**TOWN OF BAY HARBOR ISLANDS
DEVELOPMENT & REVIEW COMMITTEE MEETING
THURSDAY, FEBRUARY 9, 2023**

1. Review and discussion of Site Plan Application by DDG 100 Street BHI, LLC, to construct an 18-unit Multi-Family Development to be located at 1130 - 1140 100 Street. Enclosed are the Site Plans and the Staff Report prepared by Town Planner Michael Miller.
2. Review and discussion of Site Plan Application by LDC WBHD Property Owner, LLC, to construct a 9-unit Multi-Family Development to be located at 9110 West Bay Harbor Drive. Enclosed are the Site Plans and the Staff Report prepared by Town Planner Michael Miller.
3. Review and discussion of Site Plan Application by 1177 Bay Harbor Islands, LLC, for a revision to the previously approved New Commercial Mixed Used Building to be located at 1177 Kane Concourse. Enclosed are the Site Plans and the Staff Report prepared by Town Planner Michael Miller.

Subject: Site Development Plan Application (#2 Review)
1130 - 1140 100th Street – New Multi-family Residential Complex (18 DU)
Bay Harbor Islands Acct. No.: SPR23-000001
MMPA Acct. No. 01-0702-1151

TITLE
BUILDING ELEVATION
WEST

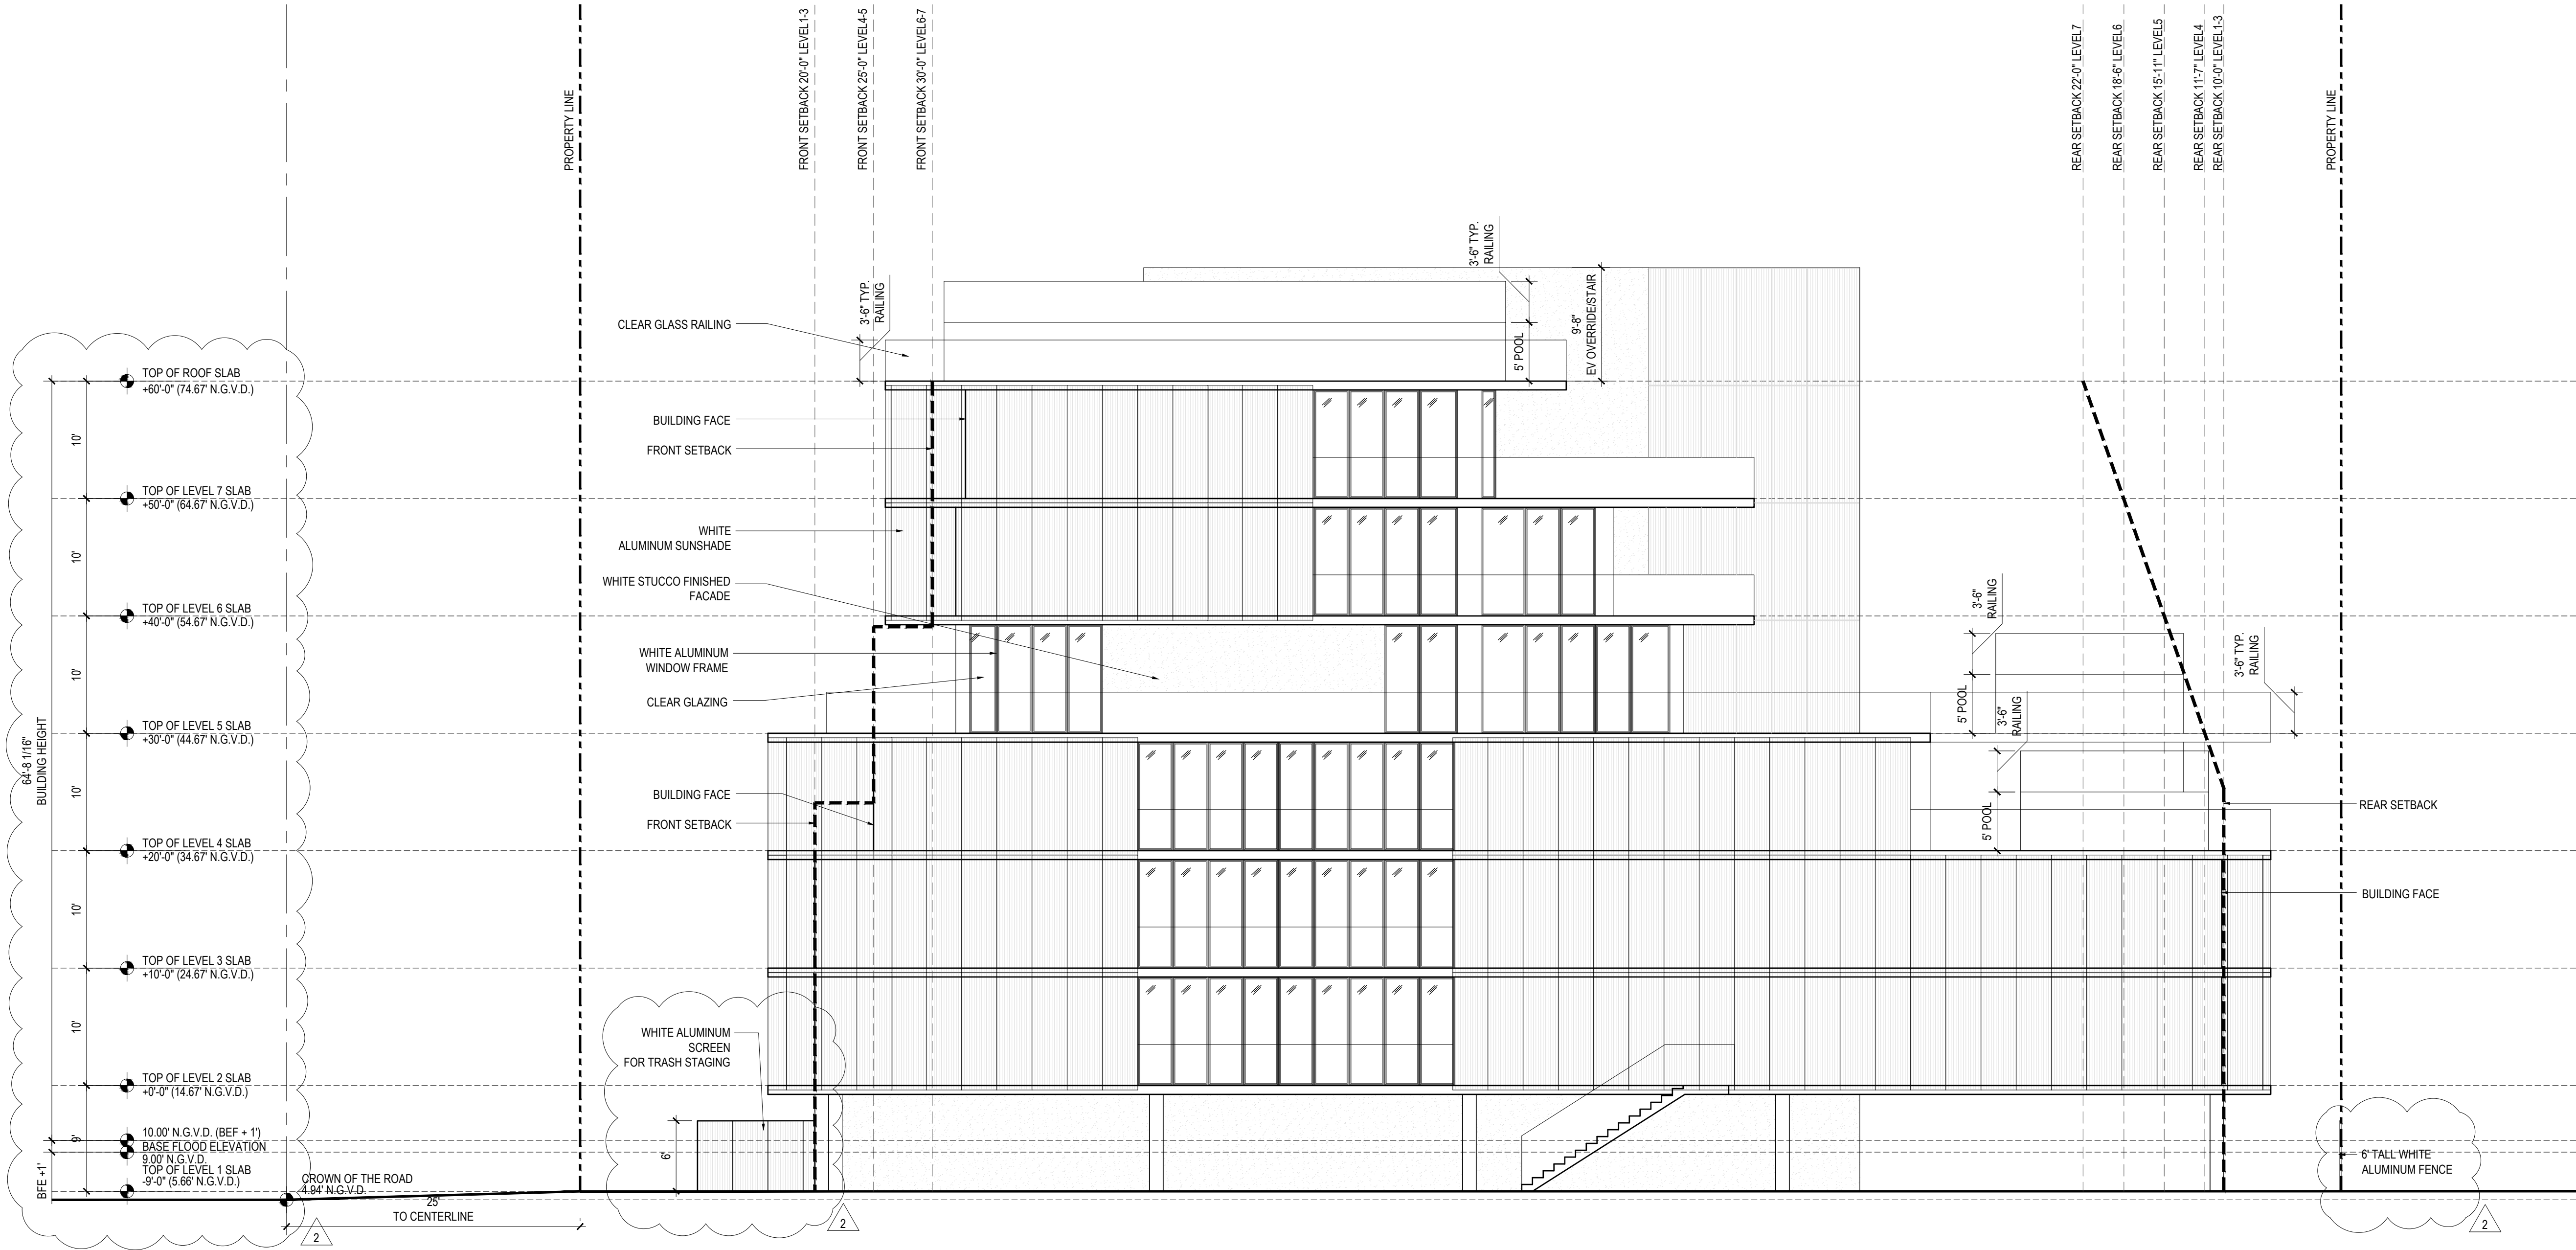
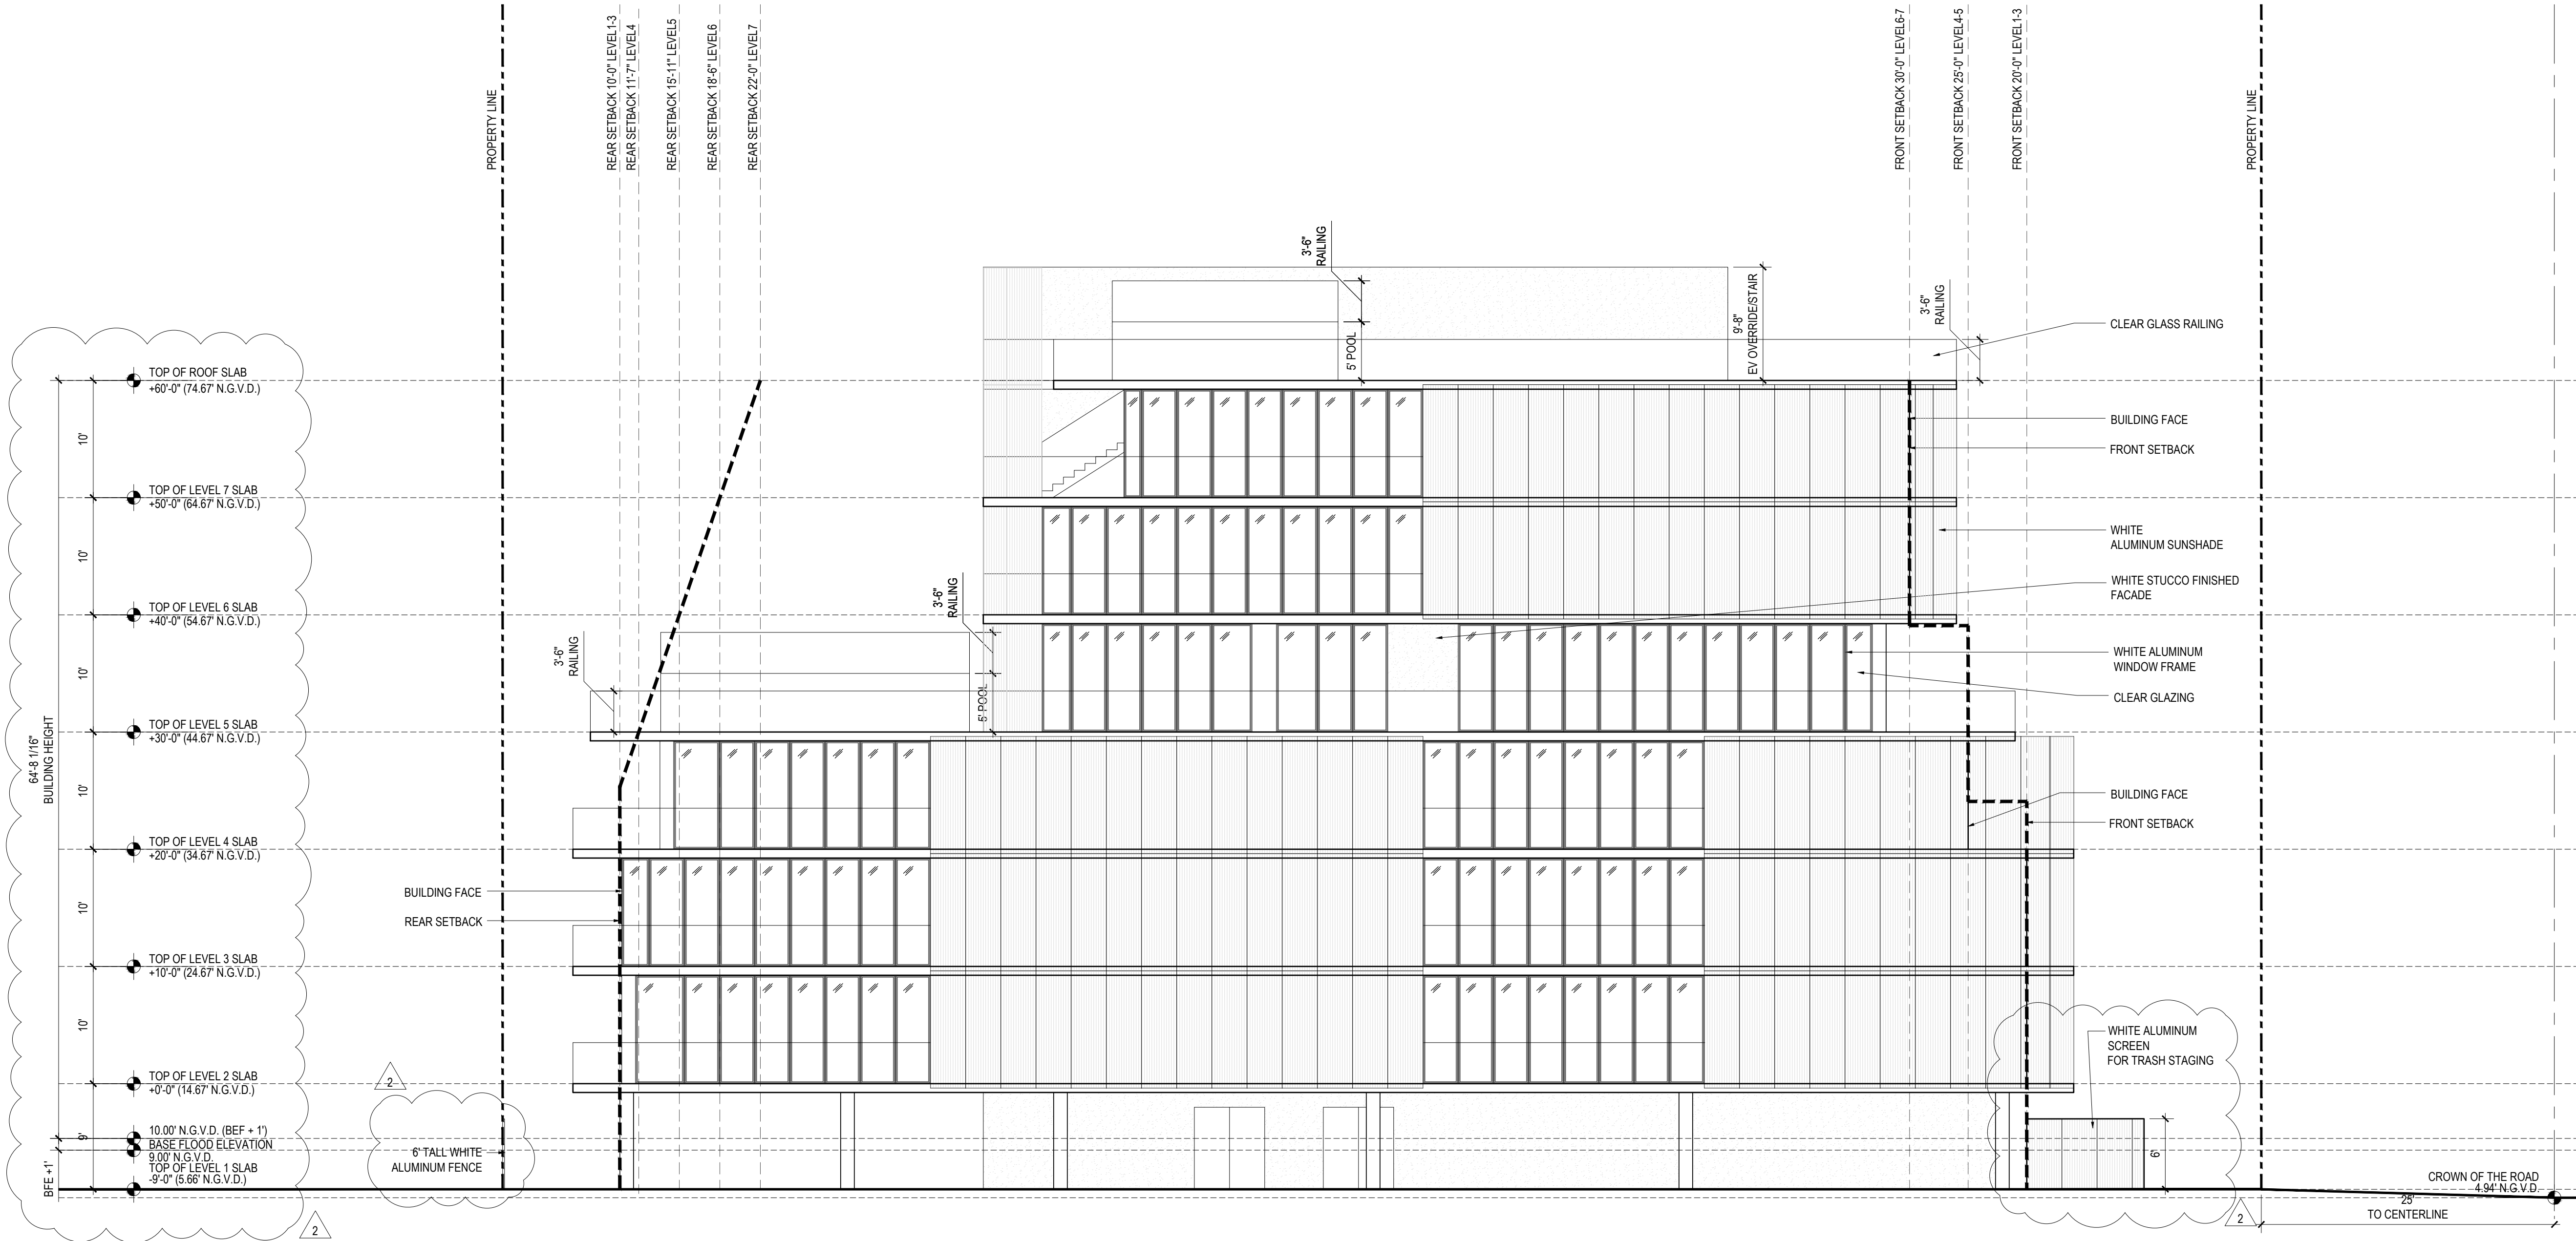
8) The building height measurements appear to incorrect oni the building elevations sheets - need clarity. Allowable building height is measured from the current FEMA BFE + 1' of FBC freeboard. The current FEMA flood map depicts two flood zones on this site (split N/S in middle of the site) as AE-8.0' and AE-9.0' NGVD- so the more stringent applies. Therefore, the lowest habitable floor must be 9.00' NGVD + 1' FBC freeboard or 10.0' NGVD. The plans show a BFE elevation of 10.67' NGVD. FEMA should be adopting a new Flood Map for Miami-Dade County shortly (draft been reviewed for some time). The new draft FEMA map will show 7.0' NAVO for the entire Town (now 3 different flood zones). When the new FEMA map is adopted and becomes effective the elevation will be 7.0' NAVO + 1' FBC Freeboard = 8.0' NAVO. Using the math conversion for NAVO/ NGVD of 1.67' the future required BFE flood elevation/ elevation at which building height is measured will be 9.67' NGVD. The plans show building height measured from 10.67' NGVD. Revise the plans.	Plans have been revised accordingly and dimensions have been provided. Building height is measured from 10.0' NGVD, which is BFE 9.0' plus 1' freeboard, and is 64'-8 1/16". Please see sheets A-21, A-22, A-23, A-24 and A-41.
